SERVICE TECHNICAL INFORMATION

ONE POINT REPAIR

UTSUNOMIYA, JANUARY 17, 1999
 REF. NO.: SI-98-041
 CUSTOMER RELATIONS & SERVICE DIV.

MODEL : HS-JX869, 879, and 8000

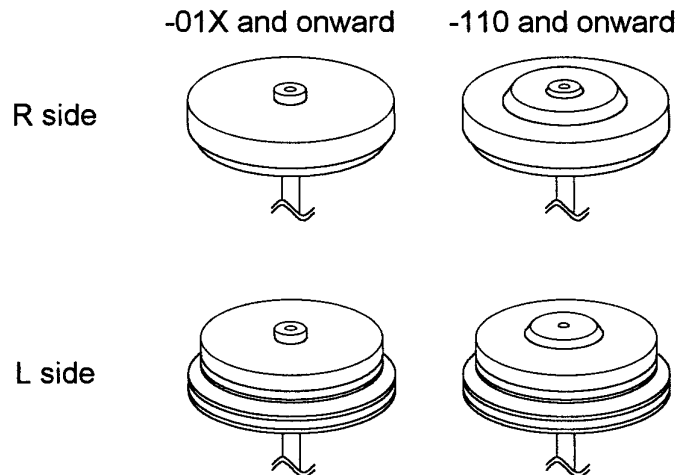
DESCRIPTION : Some units employed flywheels which are different from ones specified by the service manual. Flywheels which have part numbers ending with "-01X" have no compatibility with later ones, which have part numbers ending with "-110" and onward.

REMEDIES : Study the following figures and use appropriate flywheels on each unit.

Ref.	Part Name	Part No.	Remarks
	FLY-WHL,ASSY L M-6 REC FLY-WHL,ASSY R M-6 REC	87-ZM6-224-110 87-ZM6-220-210	L side flywheel (specified by the service manual) R side flywheel (specified by the service manual)
	FW,REC L ASSY FW,REC R ASSY	87-ZM6-224-01X 87-ZM6-220-01X	L-side flywheel ("-01X" part number) R-side flywheel ("-01X" part number)

The parts specified above cannot be substituted by any other parts.
